Project	IEEE 802.16 Broadband Wireless Access Working Group < http://ieee802.org/16 >	
Title	Enhanced MIMO support for Cellular OFDMA Systems using Midambles	
Date Submitted	2004-08-31	
Source(s)	<p>Sriram Mudulodu, K. Giridhar, Erik Lindskog, Kamlesh Rath, Aditya Agrawal, Bob Lorenz, Babu Mandava, A. Paulraj</p> <p>Beceem Communications, Inc.</p> <p>Sung-Eun Park, Wonil Roh, Seung-Hoon Choi, JeongTae Oh, Chan-Byoung Chae, Kyunbyoung Ko, Hongsil Jeong, Sung-Ryul Yun, Seungjoo Maeng, Panyuh Joo, Jaeho Jeon, Jerry Kim, Soonyoung Yoon</p> <p>Samsung Electronics Co., Ltd.</p> <p>Wen Tong, Peiying Zhu, Jianglei Ma, Ming Jia, Hang Zhang and Mo-Han Fong</p> <p>Nortel Networks</p> <p>Yossi Segal, Itzik Kitroser, Yigal Leiba, Eli Shasha, Zion Hadad</p> <p>Runcom Technologies Ltd.</p> <p>Jason Hou, Jing Wang, Sean Cai, Dazi Feng and Yonggang Fang</p> <p>ZTE San Diego Inc.</p> <p>Anand Dabak, Srinath Hosur and David Magee</p> <p>Texas Instruments</p>	<p>smudulodu@beceem.com Voice: +1-408-387-5019</p> <p>se.park@samsung.com Voice: +82-31-279-5249</p> <p>wentong@nortelnetworks.com Voice: (613)-763-1315</p> <p>yossis@runcom.co.il Voice: +972-3-9528440</p> <p>jhou@ztesandiego.com Voice: 858-554-0

Figure xxxx Midamble FUSC structure (frequency domain)

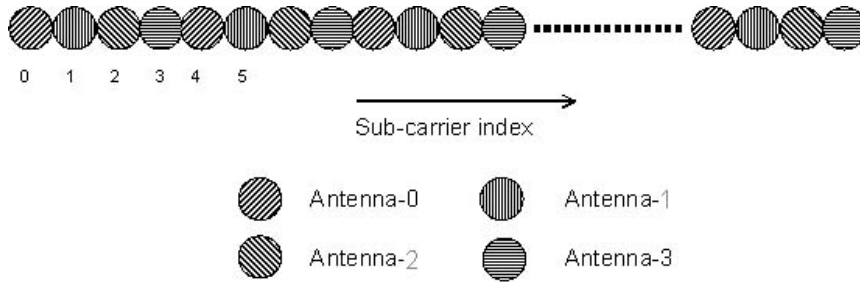
For FUSC and optional FUSC, the antenna to subcarrier mapping is shown in Figure xxxx. Subcarriers index starts from the first one after the left guard band. DC subcarrier is also included in the numbering but nulled prior to transmission. The midamble carrier-set is defined using the following formula:

$$\text{Midamble_Carrier_Set} : -(N_{\text{used}}/2) + n + 2k * \left\lceil \frac{N_t}{2} \right\rceil$$

The subcarrier to antenna mapping is depicted in figure xxxx for the case when $N_t = 4$. The midamble sequence has the identical IDcell and segment mapping as the preamble.

Figure yyyy Midamble PUSC structure (frequency domain)

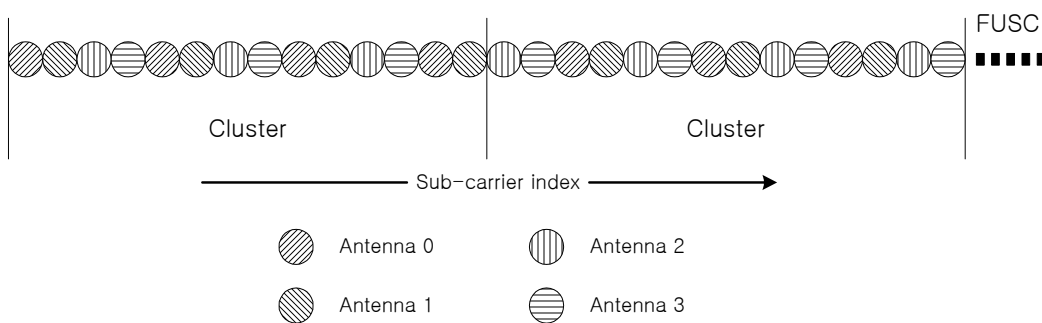
For PUSC, the subchannel permutations and grouping remains same as for the data. Instead all the subcarriers are used as pilots. Only one symbol is used as the midamble. The midamble is allocated to the subcarriers and antennas as follows.

$$\text{Midamble_Carrier_Set} : -(N_{\text{used}}/2) + n + N_t k$$

Figure yyyy shows the antenna to subcarrier mapping for the case when $N_t = 4$.
